2016 - 2017 Cadillac ATS-V and CTS-V: GM TechLink: #16-NA-399: Information on Replacing Half Shaft Fasteners with Revised Parts

#16-NA-399: Information on Replacing Half Shaft Fasteners with Revised Parts - (Feb 28, 2017)

Subject: Information on Replacing Half Shaft Fasteners with Revised Parts

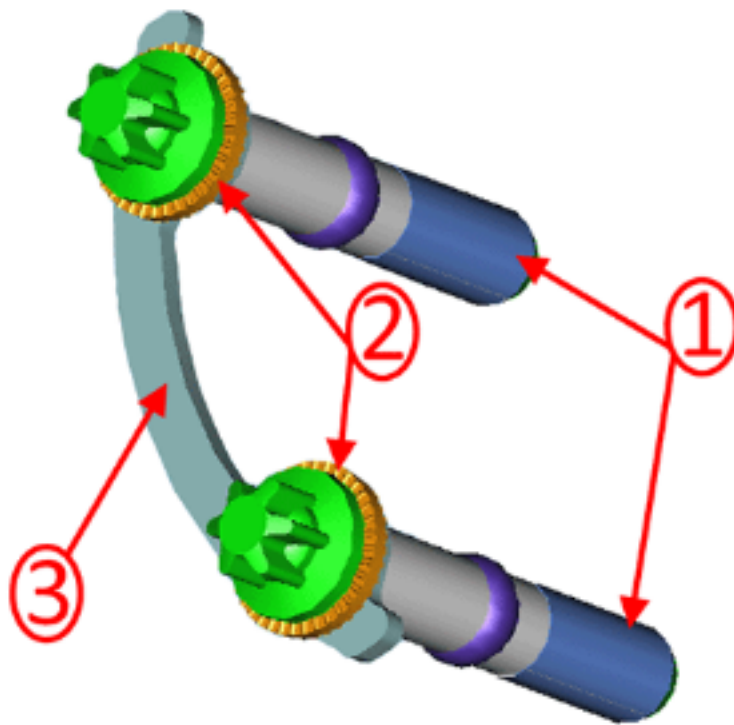
- Three retainer assemblies required per half-shaft.
 - Each retainer assembly consist of 2 longer length bolts (1), 2 lock washers (2) and 1 retainer (3).
 - Where applicable, each axle assembly uses 3 retainer assemblies per side.
 - Replacement of *all* retainer assemblies are required during repair.

This bulletin advises the Service Technician of new retainer assemblies that are required to be installed during any repair that requires the half shaft bolts to be removed or replaced.

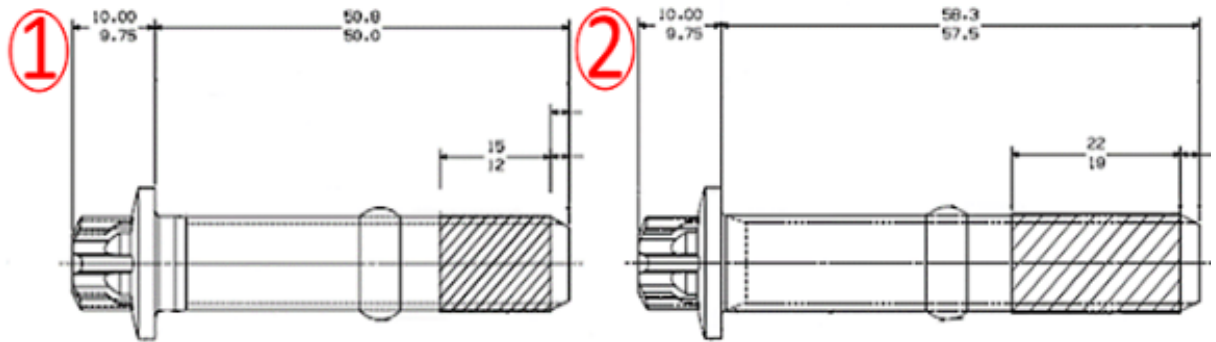
Service stock half shafts may include POA retainer assemblies that have the shorter bolt (1), these assemblies may require to be exchanged with new retainer assemblies that have the longer bolts (2).

- The new half shaft bolts must be removed, measured and discarded if the length is incorrect.

- Remove and discard retainer assemblies.
- Install new retainer assemblies.
 - Torque bolts to proper torque specifications. Refer to
